# MIAMI BEACH

### Staff Report & Recommendation

SUBJECT: DRB18-0289 (aka DRB18-0244 DRB File No. 23165)  
**122 West DiLido Drive**

**DRB18-0289 (aka DRB18-0244, DRB File No. 23165), 122 West DiLido Drive.** The applicant, Travel Charter Business LTD, is requesting exterior design modifications to a previously issued Design Review Approval for a new two-story residence. Specifically, the applicant is adding an exterior stair and elevator and requesting one or more new waivers.

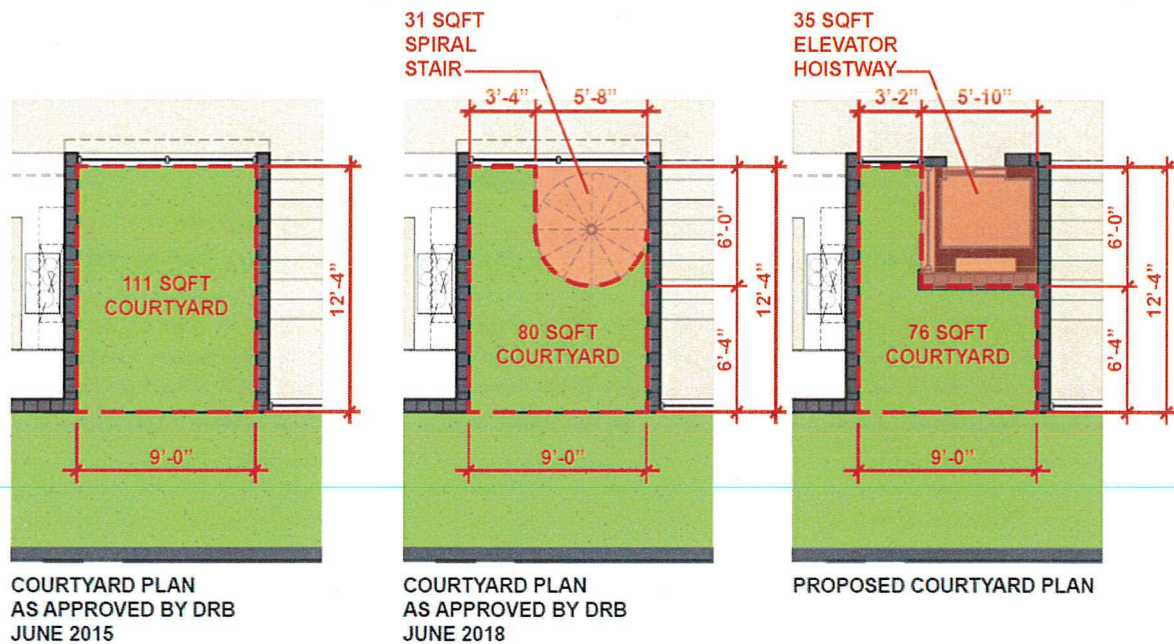
**STAFF ANALYSIS:**  
**DESIGN REVIEW**

On June 02, 2015, the Design Review Board reviewed and approved an application for the construction of a new single family two-story residence on a waterfront site. A building permit was issued, pursuant to Permit No. B1600732, and construction began per the plans approved by the DRB, which did not include a habitable roof deck or an elevator. The proposed rooftop activation obtained DRB approval on June 06, 2018, pursuant to DRB18-0244, along with an exterior stair to the roof deck; the proposed exterior elevator portion of the application was not approved. Since the prior approval meeting, the applicant has met with the abutting property owner to the south to discuss alternatives and design considerations to configure an elevator within the same required south side open space. It is staff's understanding that the abutting neighbor is not supportive of the elevator location within the side courtyard and opposes the modification to reduce the open space waiver previously granted by the Board.

Given that the construction for the new residence is well under way with the major structural work and foundations already installed, there are limited areas in which to place the vertical means of circulation to access the roofdeck, without major alterations. The applicant maintains that the addition of the proposed elevator to the side open space courtyard was found to be the most logical placement at this stage of development.

The proposed elevator, in conjunction with the new exterior spiral stair that lands on the ground, will greatly reduce the south side courtyard's open space. The approval of the exterior spiral stair at the June 2018 DRB meeting, permitted the reduced courtyard's depth from 12'-4" to 7'-0", with no overall change in lot coverage. In 2015, the south side elevation had been originally designed with the large opening recess in order to break up the façade, as outlined under Section 142-106(2)(d) of the City Code, this "open space" courtyard measured 9'-0" x 12'-4", and was fully landscaped and no waiver was needed. In June of 2018, this open space was modified to allow a spiral stair to be placed within the open space at the second level to allow access to a new roof deck; this required a new waiver to be granted by the DRB. It is important to note that the June 2018 modifications made no

changes to the ground elevation of the “open space” courtyard measured, it remained fully landscaped. Now, with the added exterior elevator and modification to the previously approved spiral stair, a modification of the previous design waiver is needed. The applicant is proposing an elevator hoist way in the same position as the previously approved spiral. The approval of the exterior elevator will further reduce the courtyard’s depth will be reduced from 7’-0” (12’-4”) to 6’-4” (12’-4”), with an overall increase in lot coverage of 54 SF, or .5%.

In order to satisfy the abutting neighbor’s initial concerns and the discussion by Board members at the June DRB meeting, the new revised design features an elevator with a south wall that is solid in nature, clad with wood. Landscape in the form of blue bamboo has also been added in order to better blend the new structure into the surrounding green space and creeping fig has been incorporated to grow up and along the vertical circulation element. Staff finds that the modified design—the proposed elevator—has addressed the intent of the regulation since the designated open space continues to successfully break up the massing of the two-story elevation, in more or less the same manner as the DRB modified in June of 2018. However, elevator bulkheads generally should be located as close to the center of the roof as possible in order to be visually recessive. This is not the case in this modified design. Further, the applicant is proposing a new exterior spiral stair proposed towards the one-story garage of the house which will rise from grade. In addition to creating an awkward rooftop area through a lengthy access path, the proposal needs to be modified further in its unit size calculations.

Staff has no objection to the requested modification of the open space courtyard to include an elevator. The abutting property is the sole impacted property, due to the proposed location of the elevator shaft. As such, staff recommends a relocation of the elevator to a more central location within the site plan to provide rooftop access to wheelchair bound individuals. However, if the affected property owner to the south is supportive of the current design modification, staff will withdraw the redesign recommendation.

Based on this analysis, staff recommends continuance of the application to a future date in order to address neighbor concerns.
